HISTORIC LANDMARK COMMISSION
STAFF REPORT

Tom Brooks
Legalization, PLNHLC2008-00317
460 South 1200 East in the University Historic District
October 1, 2008

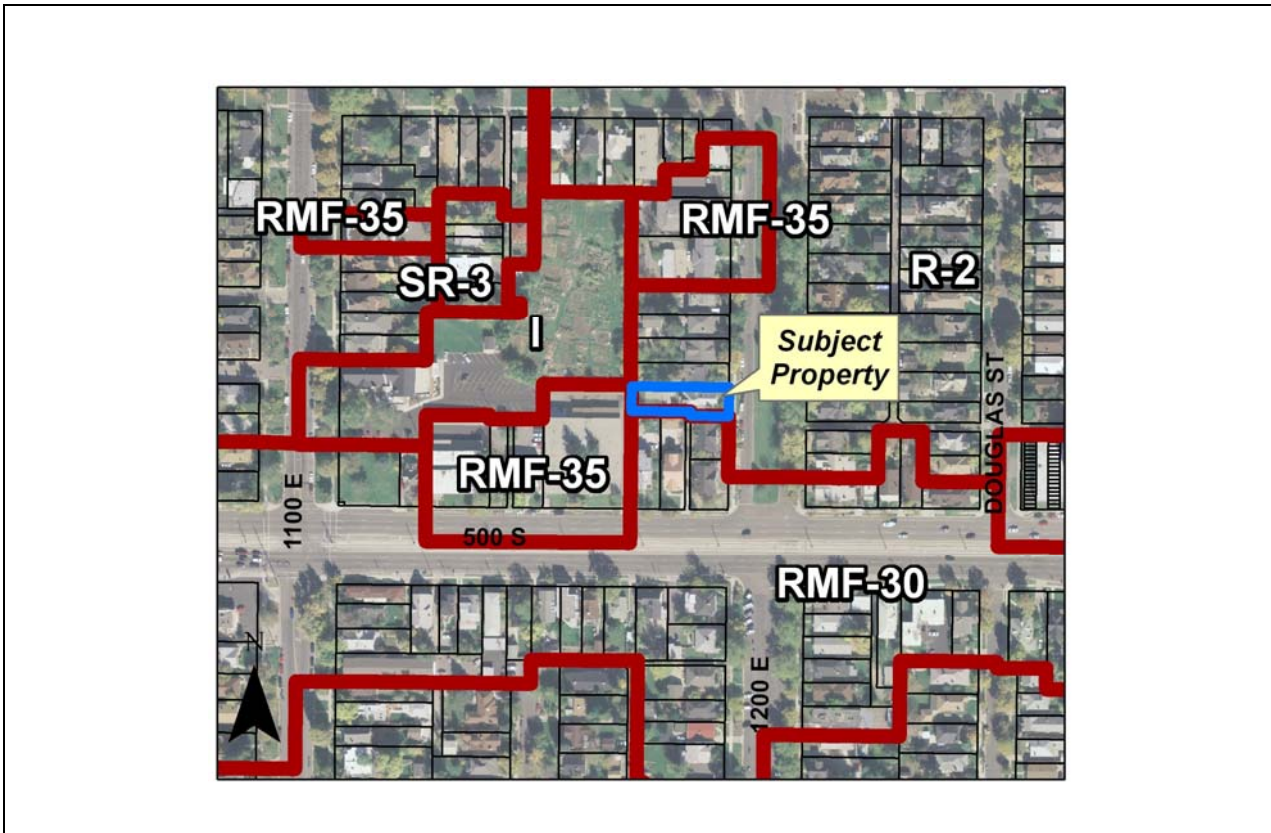
(1.) It appears that a full gable was added and covered in vinyl, rather than retaining the original clipped gable roof design. (2.) The applicant now proposes to remove the vinyl siding and fill-in with brick. (3.) In addition, a portion of the front brick wall was extended to form an arched entrance in front of the existing main entrance.

Discussion for Standards 2, 5, and 6: (1.) The home originally had a clipped gable roof, also known as a jerkin-gable. After a fire in late 2007, the property owners reconstructed the roof as a full gable, rather than as a clipped gable. The design guidelines state that the roof is a major character defining feature of a house. According to *American Vernacular Design, 1870 to 1940*, a gable roof's "visual impact derives from the broad expanses of roof, from major accent points along the roof's lines, and from the gable end itself. . . Flared roofs and clipped gables are used in designs attempting to convey rustic effects." (37)

(2.) The applicant now proposes to remove the vinyl in the gable field of the alteration and replace with brick.

(3.) The front wall of the house has been extended to create an arched entrance in front of the main entrance creating an illusion of an extension of the main façade and obscuring the view of the main entrance.

Finding for Standards 2, 5 and 6: (1.) The alteration does not meet these standards since the original design of the roof has been significantly altered and the original design was not preserved. (2.) The request to change materials in the gable field does not meet the criteria since the overall alteration itself, which has already taken place, does not meet the criteria and will only make the alteration less compatible with the original style of the house. (3.) The archway adds a design feature that is not original to the house or the style and obscures the front entrance.

Discussion for Standard 3: (1.) For this particular house a gable roof without the clipped ends is not a part of the original design of the house. (2.) Vinyl is not a material that would have originally been used on a house of this age or style. (3.) The front archway is not a part of the original design of the house.

Finding for Standard 3: (1. and 3.) The alterations that have already taken place do not meet this standard since their designs alter the original design of the house, create a false sense of history, and are readily visible from the street. (2.) The request to change materials in the gable field does not meet the criteria since the overall alteration itself, which has already taken place, does not meet the criteria and will only reinforce a false sense of history.

Staff recommends that the Historic Landmark Commission deny the alteration as it does not meet any of the standards of section 21A.34.020 G of the zoning ordinance. This recommendation is based on the Discussion and Findings of Fact in the staff report.
